STAFF RECOMMENDATION
1900 Fatherland Street
June 15, 2016

Application: New construction—Outbuilding; Setback determination
District: Lockeland Springs-East End Neighborhood Conservation Zoning Overlay
Council District: 06
Map and Parcel Number: 08314022200
Applicant: Kaitlyn Smous, Nine12 Design
Project Lead: Melissa Baldock, melissa.baldock@nashville.gov

SITE PLAN
 SCALE: 1/16"=1'-0"

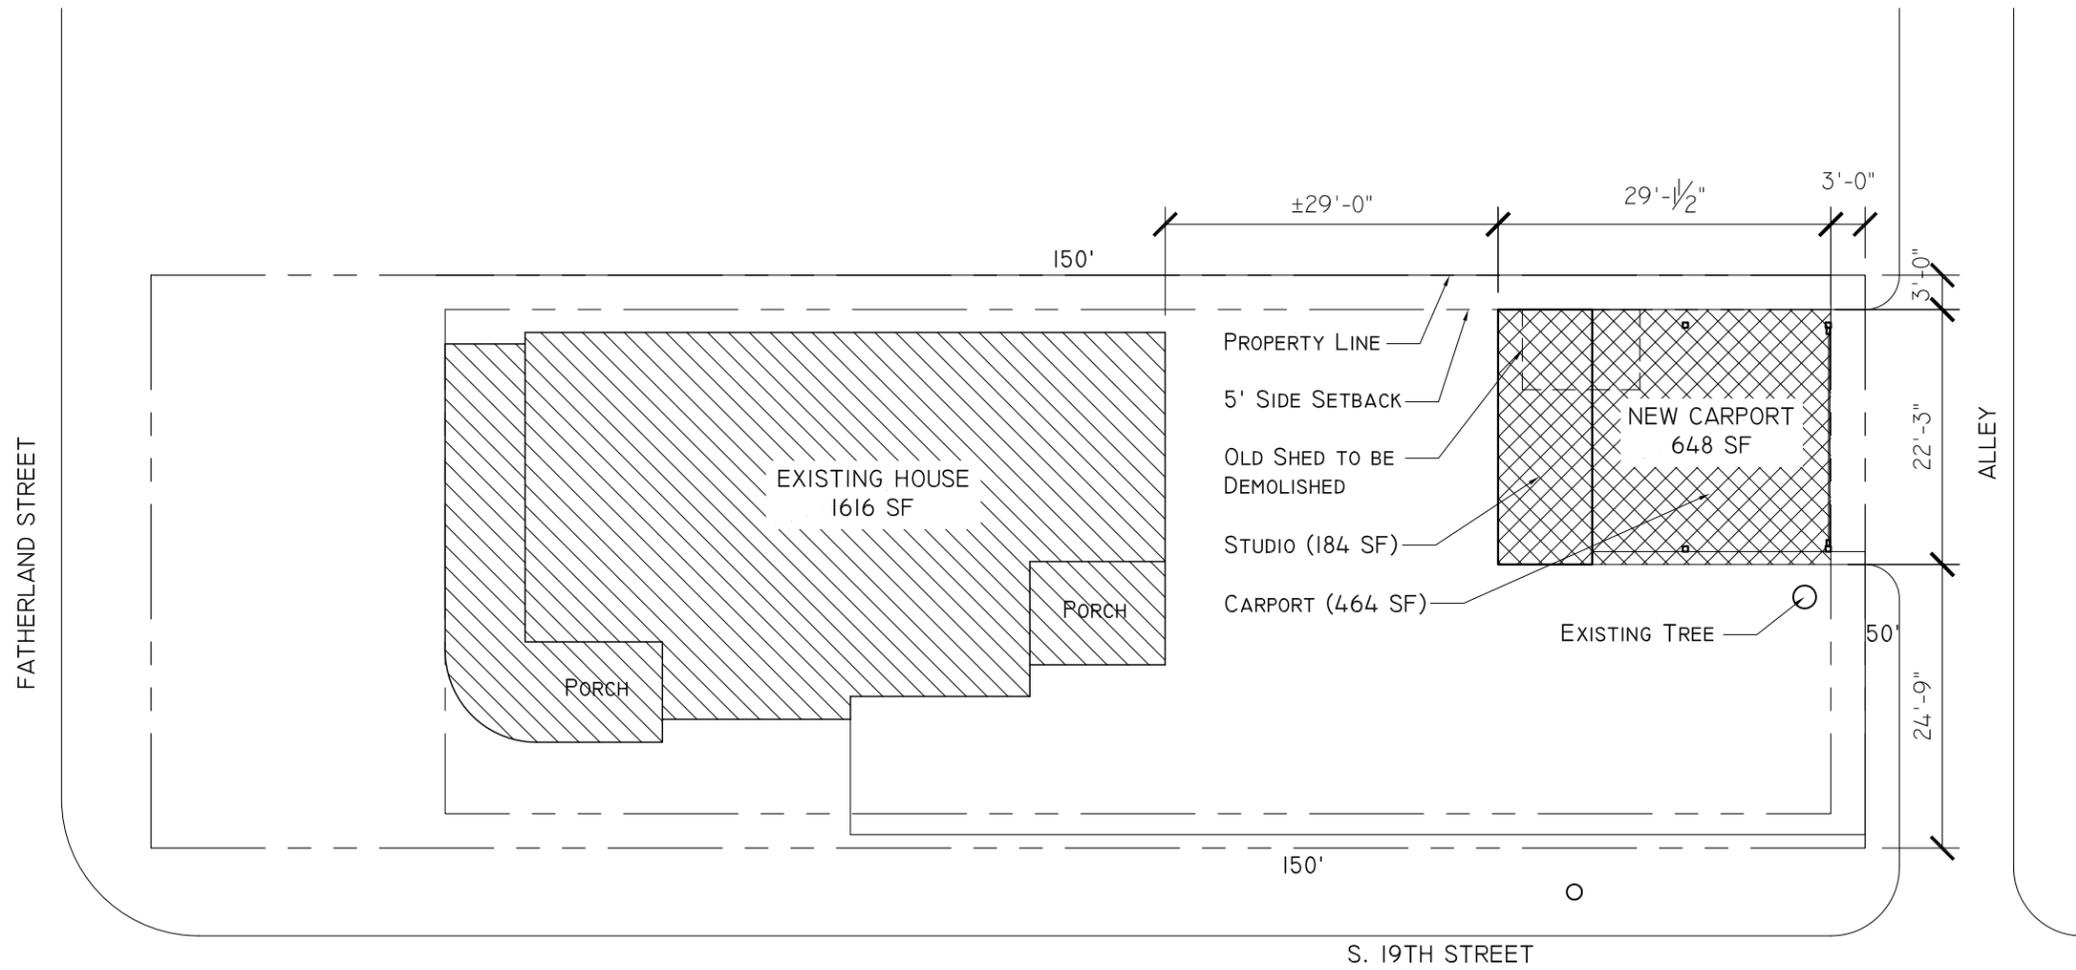
The new outbuilding does require a rear setback determination. Base zoning requires that outbuildings that have garage doors that face the alley be a minimum of ten feet (10') from the rear property line. The applicant is proposing to locate the outbuilding just three feet (3') from the rear property line. Staff finds that the proposed rear setback is appropriate because, historically, outbuildings were located at the rear of the property, close to or even on the rear property line. An analysis of existing outbuildings in the immediate vicinity shows that there are several outbuildings that are located just a few feet or even on the rear property line. Staff recommends approval of the rear setback determination.

ELEVATIONS

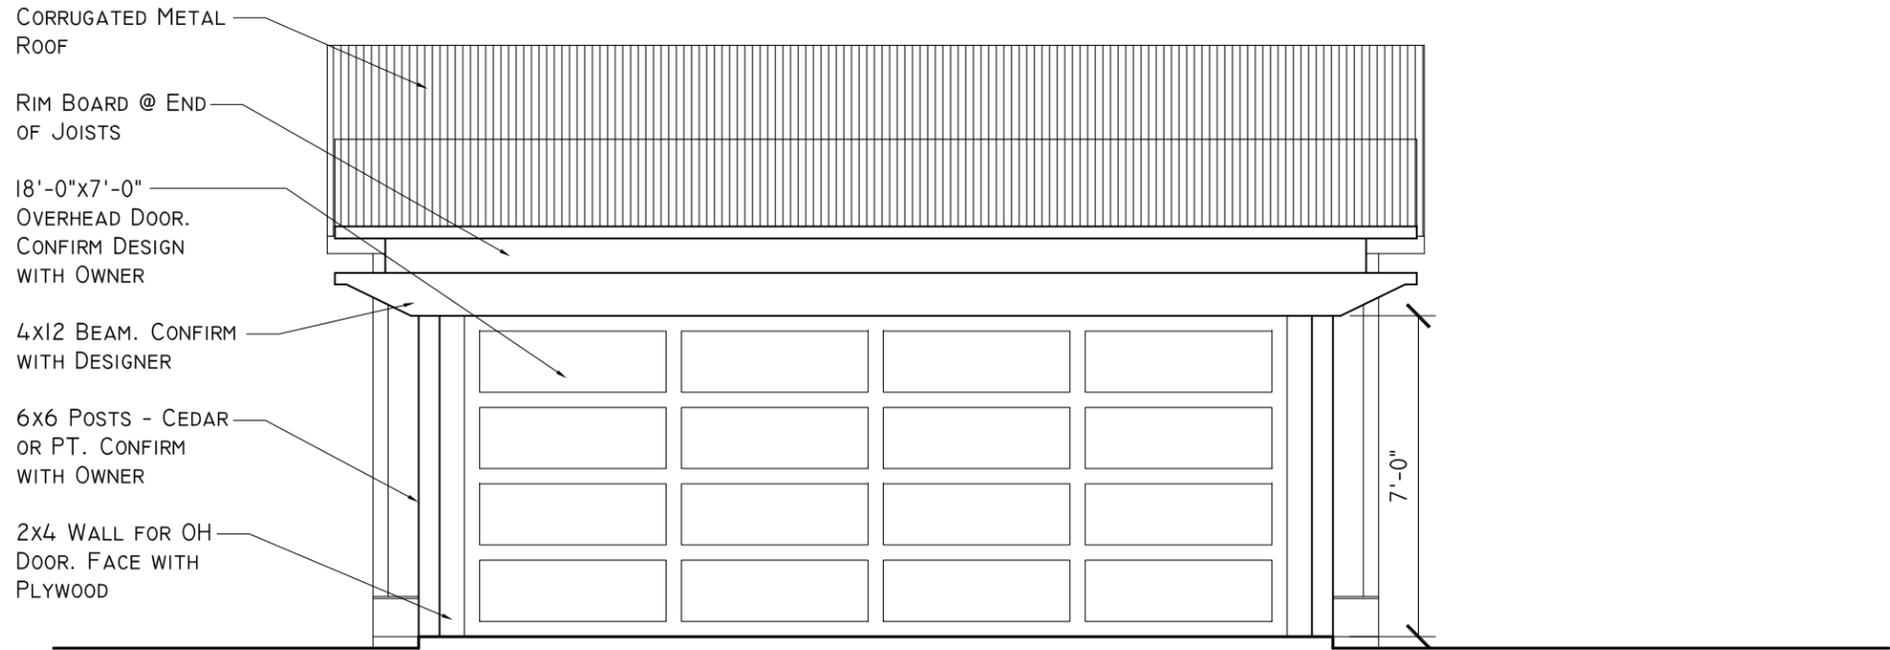
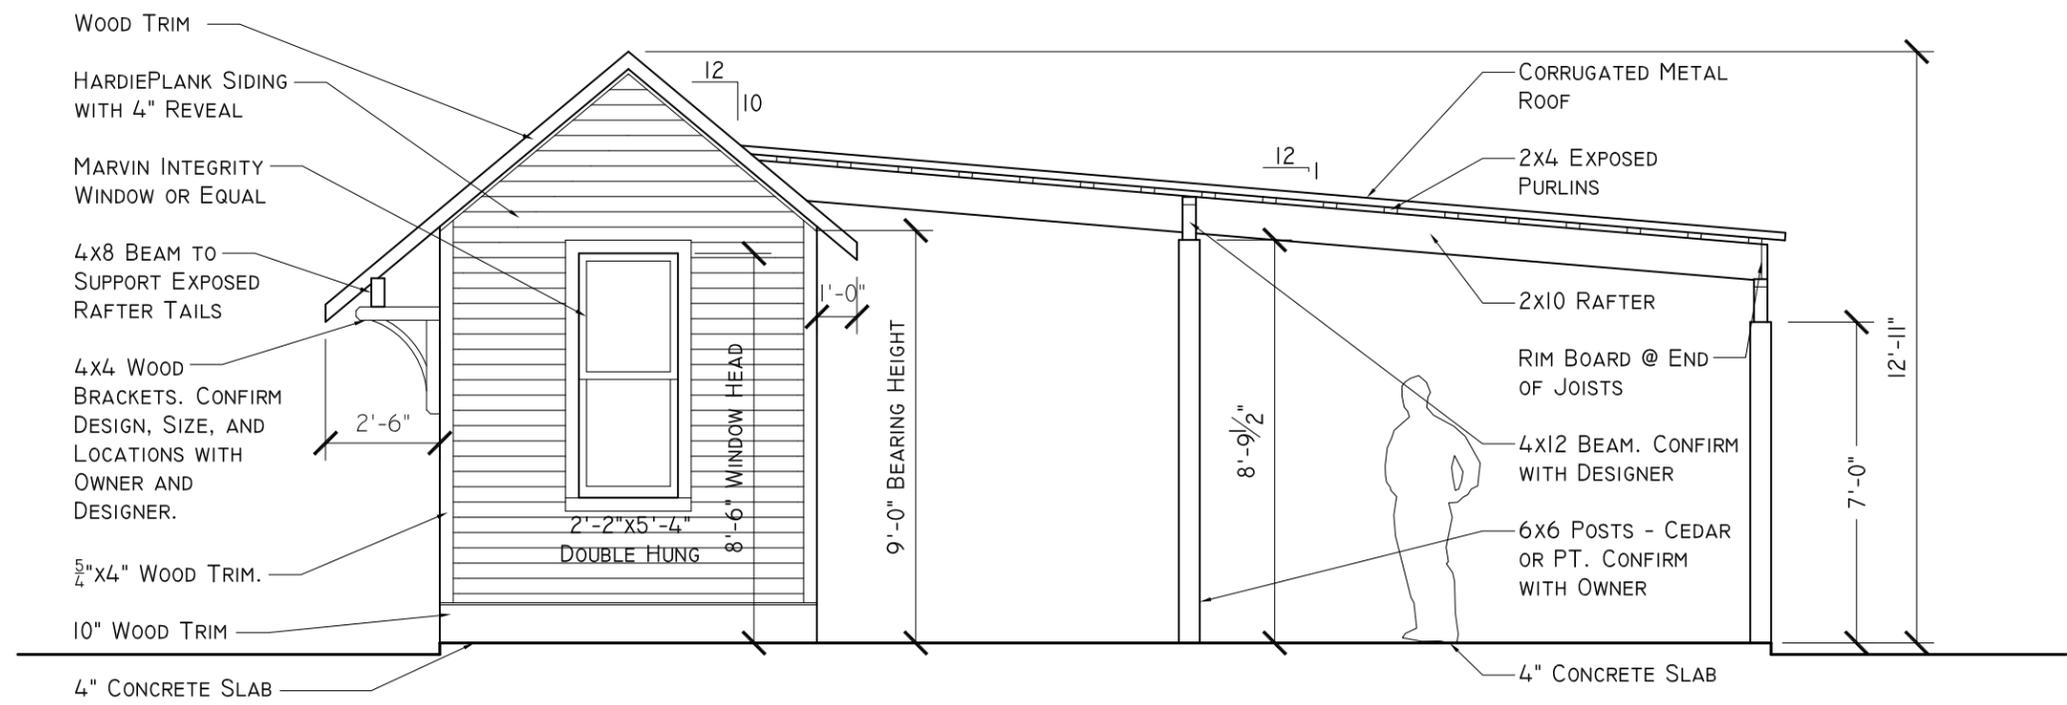
The proposed outbuilding will include a storage area and a carport, with a total footprint of six hundred and forty-eight square feet (648 sq. ft.). The carport has garage doors that face the alley. It will be one story with a maximum height of twelve feet, eleven inches (12' 11"), and thus will be subordinate to the historic house. The materials for the outbuilding have all been approved by the Commission in the past, and include cement fiberboard siding with a five inch (4") reveal, wood trim, wood brackets, Marvin Integrity windows, metal garage and pedestrian doors, concrete slab foundation and a corrugated metal roof. Staff asks to approve the roof color and texture prior to purchase and installation.

Recommendation Summary: Staff recommends approval of the outbuilding with the condition that staff approve the roof material color and texture prior to purchase and installation. With this condition, staff finds that the outbuilding meets Section II.B. of the *Lockeland Springs-East End Neighborhood Conservation Zoning Overlay: Handbook and Design Guidelines*.
